**CITY OF BLOOMINGTON
PLAN COMMISSION AGENDA
July 8, 2013 @ 5:30 p.m.**

**BLOOMINGTON PLAN COMMISSION
STAFF REPORT
LOCATION: 117 E. 6th Street**

**BLOOMINGTON PLAN COMMISSION
STAFF REPORT
LOCATION: 1140 S. Morton Street**

**BLOOMINGTON PLAN COMMISSION
STAFF REPORT
Location: 701 N. Walnut Street**

SP-31-13
 South and East
 Elevations

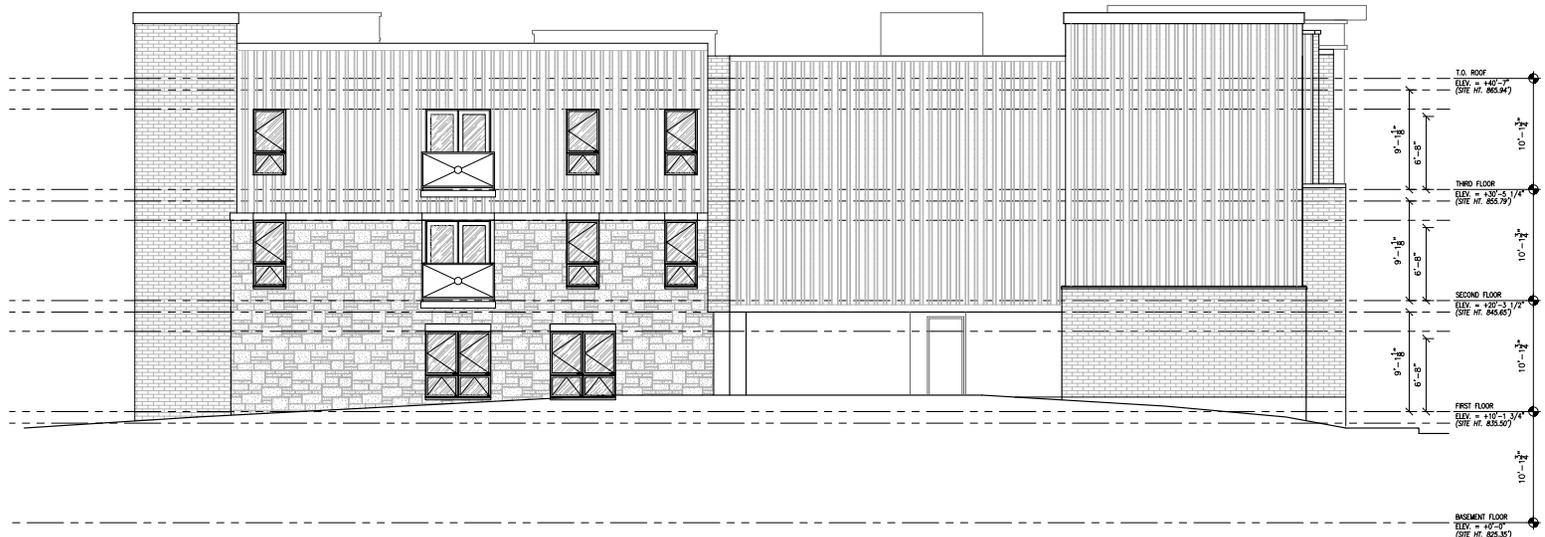
Materials: The building is clad with a combination of brick, limestone and metal siding on the front along Walnut St. and 11th Street. The petitioner intends to reuse much of the limestone from the existing building, especially on some retaining walls on the site. The north and west sides of the building are shown with large expanses of metal siding that exceed the 20% permitted for a “secondary material.” The petitioners have indicated an intention of changing much of this metal siding to cementitious siding, but have not yet submitted revised elevations.

In this case, staff believes that the void-to-solid may be appropriate given the building's residential use. There are not areas of blank wall that lead staff to believe that the proposed ratio is inadequate. In staff's view there are still questions about whether a step back or shorter building should be considered along the Walnut St. façade. The proposed building height at the northeast corner is approximately 11 feet higher than the adjoining building to the north.

- 1.) The most common usage of metal panels for downtown buildings is typically to add small accents of color or denote recessed upper stories. In this instance, metal is being proposed over multiple stories, particularly on the northeast end.
- 2.) There is a good deal of usage of stacked stone beyond the building base. This use continues over multiple stories and also frames the corner tower element. The Commission should consider whether this multi-story treatment is a positive design element at this important corner property.

SP-31-13
 Landscaping/Site Plan

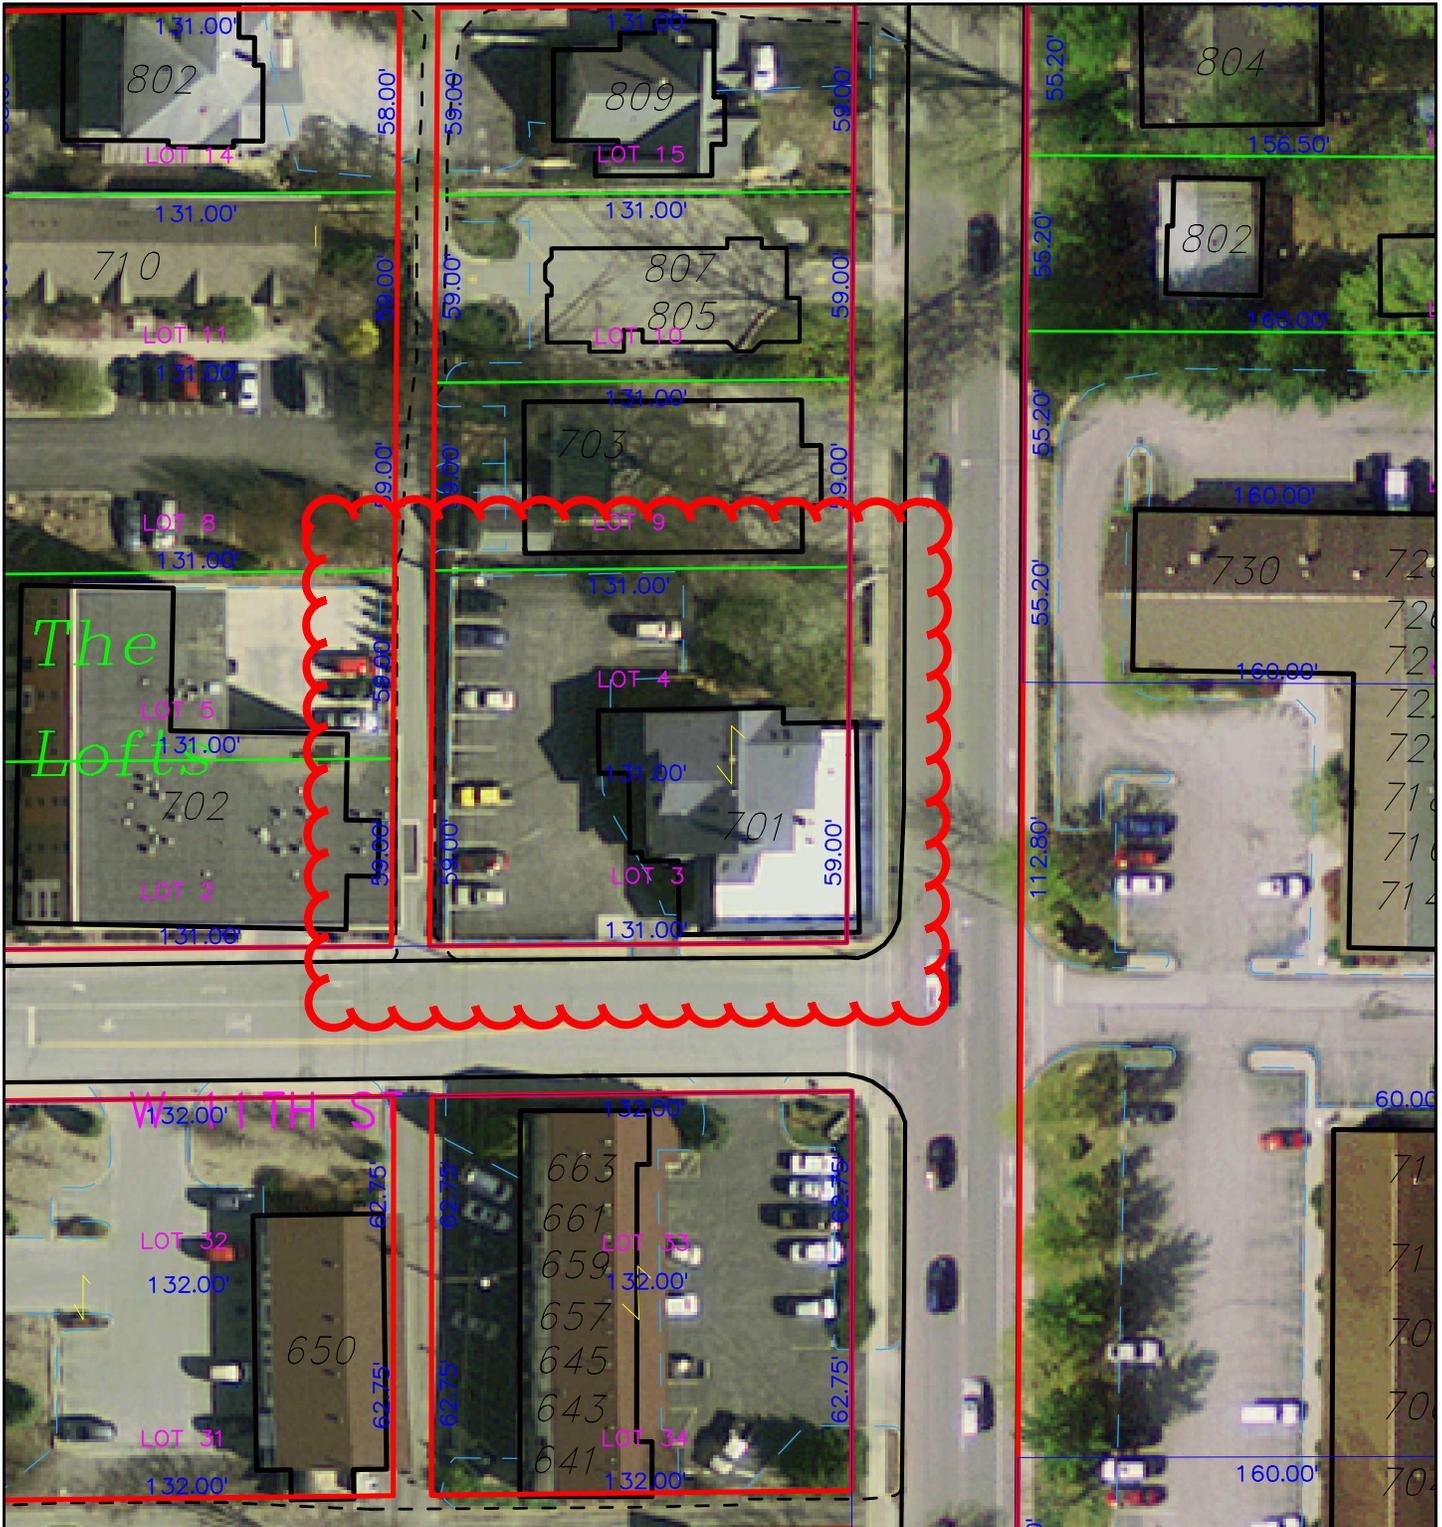
Landscaping: A complete landscaping plan has not been submitted. Landscaping of the green areas of the site and around the surface parking lot are required.

The Landscape Plan is incomplete. The Petitioner needs to submit a complete plan for review. With specific regard to the proposed street tree and lawn plantings, the EC recommends that the developer work with the Planning Department and the EC to create diverse tree, shrub, and native perennial plantings that exemplify Indiana's natural heritage. For suggestions, please see the EC's Natural Landscaping materials at www.bloomington.in.gov/beqi/greeninfrastructure/htm under 'Resources' in the left column. For additional suggestions plus an excellent guide to Midwest sources of native plants see: <http://www.inpaws.org/landscaping.html>. Attractive educational signage could also be considered for this area. Native plants provide food and habitat for birds, butterflies and other beneficial insects, promoting biodiversity in the city. Furthermore, native plants do not require chemical fertilizers or pesticides and are water efficient once established.

- 1.) The Petitioner shall submit a complete landscape plan for review.
- 2.) The Petitioner should apply green building and site design practices to create a high performance, low carbon-footprint structure.
- 3.) The Petitioner should provide space for recyclable materials to be stored for collection, and a recycling contractor to pick it up.
